**CITY OF SEATTLE
ANALYSIS AND RECOMMENDATION OF THE DIRECTOR
OF THE DEPARTMENT OF PLANNING AND DEVELOPMENT**

Application Number: 3008423
Council File Number: 309623
Applicant Name: Tim Jewett of Dykeman Architects for Safeway Stores
Address of Proposal: 12318 15th Avenue NE

SUMMARY OF PROPOSED ACTION

Figure 4: Approved site Plan

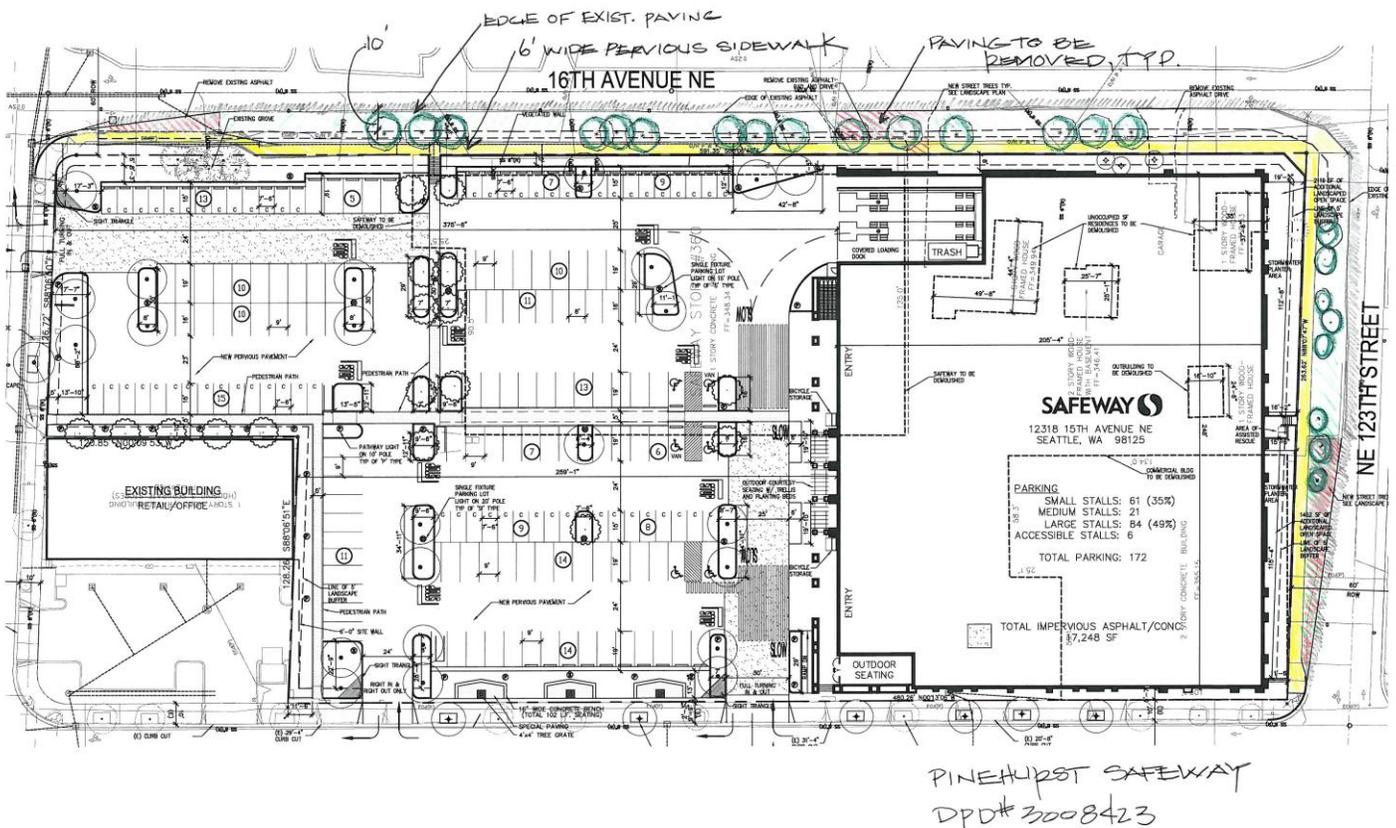
store program, the transparency along 15th Ave NE is adequate. However, they felt that the transparency stopped abruptly at the corner with NE 123rd creating an unfriendly aspect at the corner. Because this corner is highly visible to vehicles northbound on 15th Ave NE, the Board recommended that the design “wrap” the transparency around the corner onto NE 123rd and add some additional visual interest at this corner facade. Wrapping the overhead weather protection around the corner was also recommended.

The long, open expanse along 15th Ave NE where the parking lot is located is softened somewhat by the Urban Garden. The Board liked the concept of the urban garden but recommended adding higher, more intensive, plantings at the rear of the garden to provide true screening from the parking lot and recommended moving the trees from within the seating areas to between the seating areas.

Recommendation #1: Wrap transparency around corner at 15th Ave NE and 123rd NE and add additional visual interest at this corner. Refine the design at this corner element to present a more open and friendly façade.

Recommendation #3: Add taller plantings (or low walls/berms, etc.) at the rear for the Urban Garden to provide better screening for the parking lot. Relocate proposed trees from inside the seating areas to areas in between the seating areas such that they alternate in relative location with the street trees.

The board commented that the lighting plan did not go far enough to provide nighttime visibility and security. They recommended that the design include more low pedestrian lighting on both 16th Ave NE and NE 123rd and add lighting along the vegetated wall long the parking lot. Step lighting should also be added to the stairway leading from 16th Ave NE to the parking lot.

Recommendation #8: Add more pedestrian lighting along NE 123rd and 16th Ave NE; add downcast lighting on parking lot wall along 16th Ave NE; add step lighting on stairway accessing parking lot on 16th Ave NE.

The Board had specific recommendations about the proposed Urban Garden located along 15th Ave NE which function is to screen the large parking lot. Taller plantings should be employed at the rear of the garden to provide true screening. The trees proposed for the center of each of the

three conversation seating areas should be relocated to between the seating areas giving them a better planting area and better chance for survival. This would also allow them to alternate in location with the street trees in the same area. (See Recommendation #3 above).

Following the Recommendation meeting, DPD staff worked with the applicant to update the submitted plans to include all of the recommendations of the Design Review Board. The Director of DPD has reviewed the decision and recommendations of the Design Review Board made by the five members present at the decision meeting and finds that they are consistent with the City of Seattle Design Review Guidelines for Multifamily and Commercial Buildings. The Director agrees with the Design Review Board's conclusion that the proposed project and conditions imposed result in a design that best meets the intent of the Design Review Guidelines and accepts the recommendations noted by the Board. The Director is satisfied that all of the conditions imposed by the Design Review Board have been met.
